FEDERAL APPROVAL LETTER

Joint Approval of FY 20084011 Statewide
Transportation Improvement Program (STIP)

General FHWA & FTA Comments on the FY 2008-2011 STIP (State of Texas)

FHWA-FTA Individual MPO & District Comments FY 08-11 STIP (State of Texas)

**FIGURE 1 – Revenue Sources for Highways & Transit
(Source: U.S. DOT Conditions & Performance Report, 2006)**

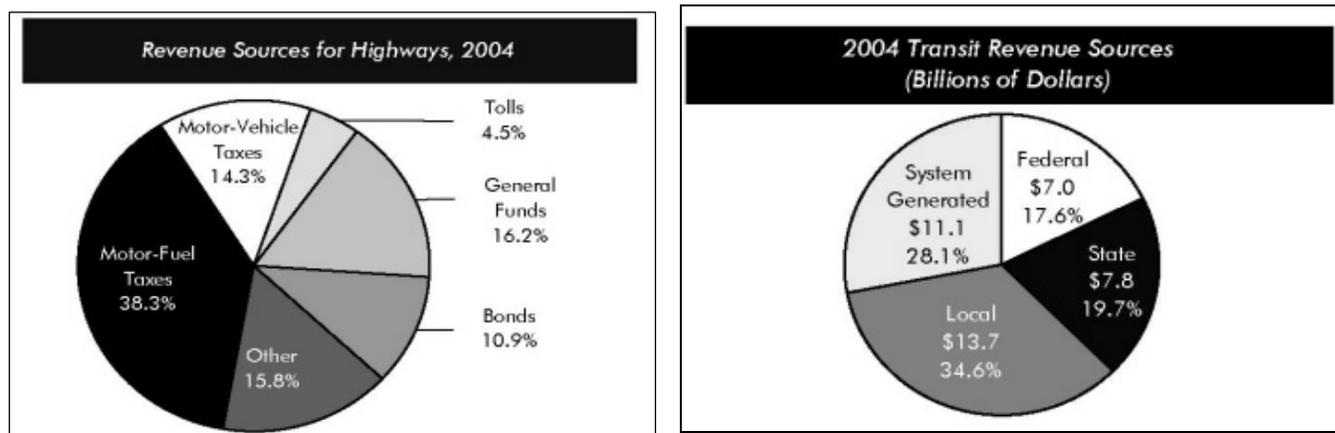
2. For purposes of illustratively demonstrating fiscal constraint of the FY 08-11 STIP under 23 CFR 450.216 it is recommended that all incoming reasonably expected revenue sources for State of Texas highway and transit revenues be shown by individual fiscal year FY 08-11 in a pie-chart graph by category of funding (e.g., Federal, state, and local including private sector contributions) per 23 CFR 450.216. Figure 1 illustrates how this could be visually documented within the STIP from an example drawn from the U.S. DOT Conditions & Performance Report, 2006.³

**FIGURE 2- Highway & Transit Expenditures by Type of Activity
(Source: U.S. DOT’s Conditions & Performance Report- 2006)**

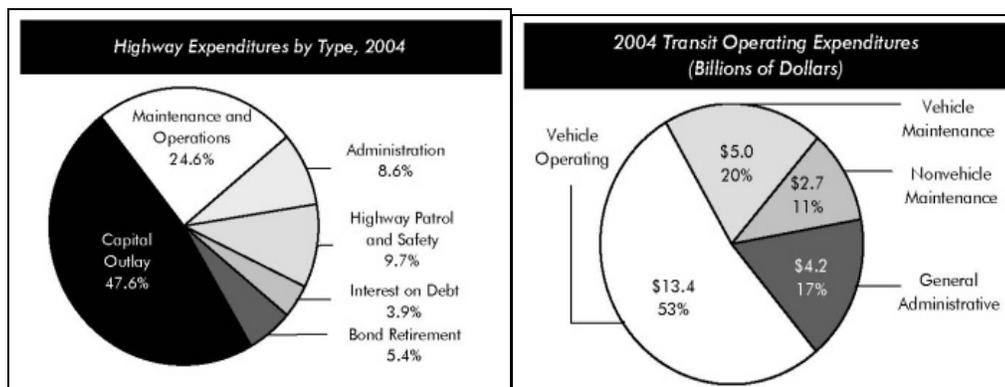
- Similarly, it is recommended that outgoing capital project expenditures (costs) by program activity for both Federal-aid highway and transit projects (statewide) could also be shown in terms of total project costs in a pie-chart by category showing individual type of work activity. The UTP may provide a good source of total Federal and state expenditures related to disbursements on an annual fiscal basis (a visual graphic example from the U.S. DOT Conditions & Performance Report, 2006 is shown below in Figure 2).⁴

FIGURE 3- Growth of the Federal-Aid Highway Program from FY 2005 to FY 2007 (State of Texas)

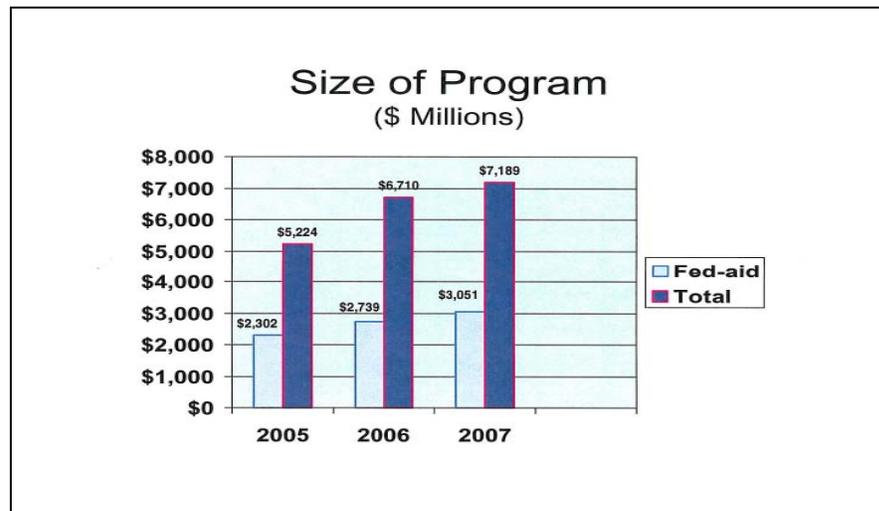
1. Over the past three fiscal years, the size of the Federal-aid highway program has grown to over \$3 B per year (See Figure 3: “Growth of the Federal-Aid Highway Program”).⁶ We would suggest a similar bar graph showing the historical levels of Federal-aid funds be useful to show in the Introduction portion of the STIP. FY 08 estimates could be used to show current (and projected in FY 09-11) for the Federal-aid highway program within the State of Texas. Please note that the financial data shown below in Figure 3 was generated from the FHWA Fiscal Management Information System (Source: FMIS Report No. W10A).

FIGURE 4- Federal/State DOT Project Development & Transportation Planning Process (State of Texas)

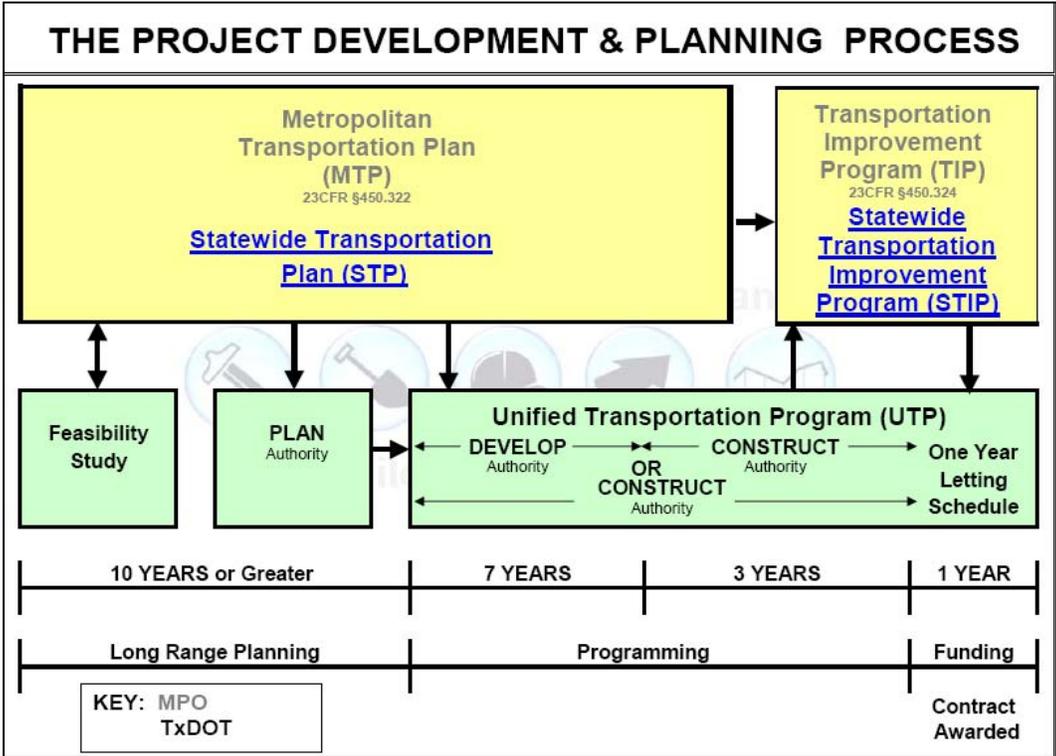
2. For purposes of better describing how the statewide planning process works to the general public, we would suggest the inclusion of the following block flow diagram (See Figure 4 –FY 2007 UTP) be incorporated within the “Introduction” portion of the STIP in order to provide a description of how the Federal/State project development and planning process is integrated within the State and local MPO long-range planning and short-range STIP/TIP programming phases.
